## ATTACHMENTS FOR: AGENDA NO. 6/13 Planning and Environment Committee

**4 66A PELLISIER ROAD, PUTNEY. LOT B DP 419543. Local Development Application for new dual occupancy. LDA2012/0106.**

**Report prepared by:** Senior Town Planner; Team Leader - Major Development Team

**Report dated:** 6 November 2012      **File Number:** grp/12/5/5/3 - BP12/1313

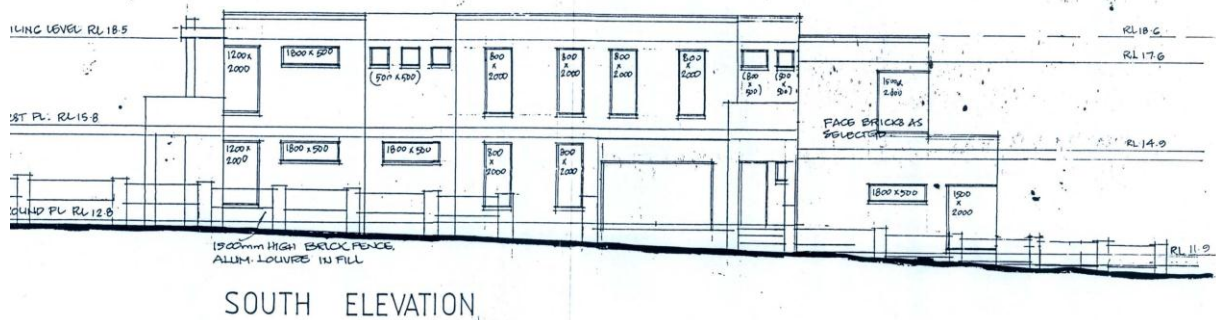
The following diagram illustrates the front elevation of the development, showing its presentation to Pellisier Road:

The southern elevation facing McGowan Street is demonstrated in the above diagram.

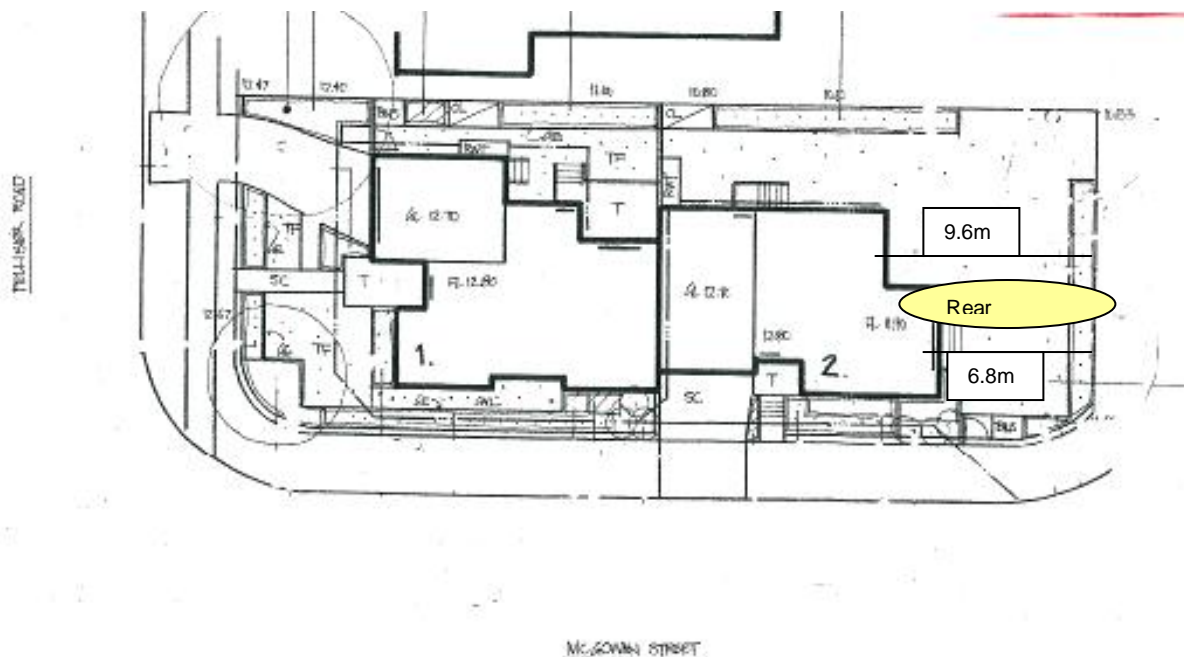
- *The site is 577.4m<sup>2</sup>, which is less than 580m<sup>2</sup> and fails on this control.*

Whilst the subject site is short of the required 580m<sup>2</sup> by 2.6m<sup>2</sup>, the applicant has submitted a written request under Clause 4.6 of RLEP 2010 for Council to consider the variation. Full discussion of the variation is assessed below under Clause 4.6.

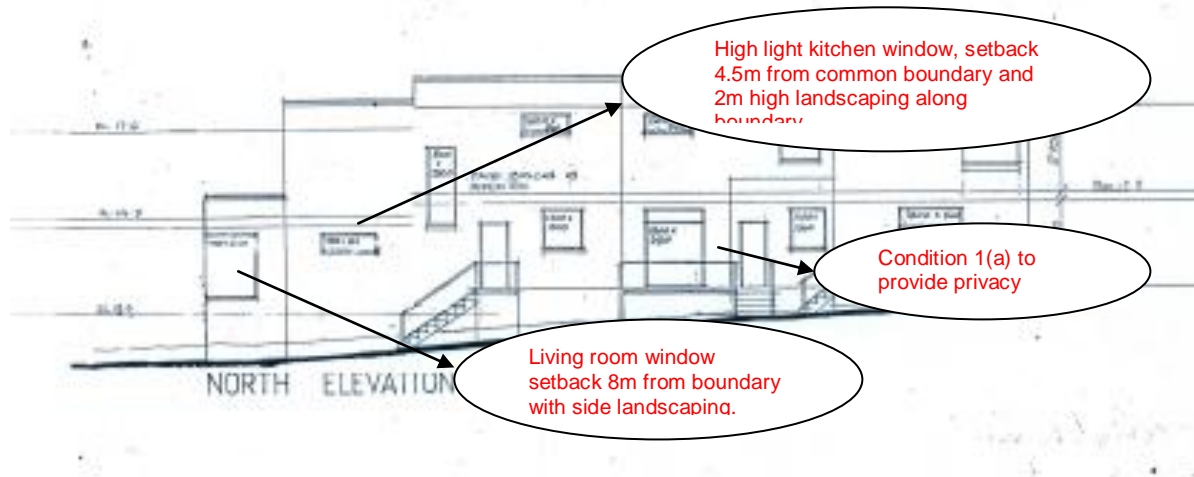
- *Visual Privacy – windows on the southern side will allow for direct visibility into the dwelling located at 68 Pellisier Road. In addition there will be a visual privacy issue to 66 Pellisier Road. There will be direct visual access into the terrace and backyard of 66 Pellisier Road. We object to the proposed development due to the adverse visual privacy implication it will cause for the properties immediately adjacent to the subject site.*

The applicant has amended the plans to provide high light windows (kitchen and laundry windows) along the northern elevation of Unit 2 which faces the rear section and rear yard of 66 Pellisier Road. The high light window will not affect the amenity of the kitchen as the kitchen contains two other windows.

Unit 2 will be setback 4.5m to 8m from the side common boundary with the rear section of Unit 2 stepped down to lower the finished floor level by 500mm. In addition to this, a 2m high landscaping strip is proposed along the northern boundary to screen and soften the development as viewed from 66 Pellisier Road. The amended proposal will minimise overlooking to 66 Pellisier Road and will result in an improvement to the current situation where the existing dwelling has an elevated rear deck with no side screening and currently overlooks into 66 Pellisier Road's rear yard area. The living room window of Unit 2 is setback 8m from the common boundary and the finished floor level has been lowered to minimise any potential overlooking. This together with the proposed and existing landscaping along the northern boundary will minimise any overlooking to 66 Pellisier Road.

With regard to Unit 1, the side garage window is not considered to pose any overlooking concerns as it is a low use area and set back 2.5m off the common boundary. However, it is proposed to provide a raised deck area off the living area, setback 3.5m off the boundary. 66 Pellisier Road has a ground floor and first floor windows in the vicinity of the raised deck area and insufficient details have been submitted to ascertain what rooms these windows are off. To protect the amenity to these windows, a privacy screen should be provided along the outer edge of the deck area. The screen is to be a fixed privacy screen and is to have a minimum height of 1.6m above the finish floor level and constructed of complimentary materials and shall not allow greater than 50% visible transparency to the adjoining property.
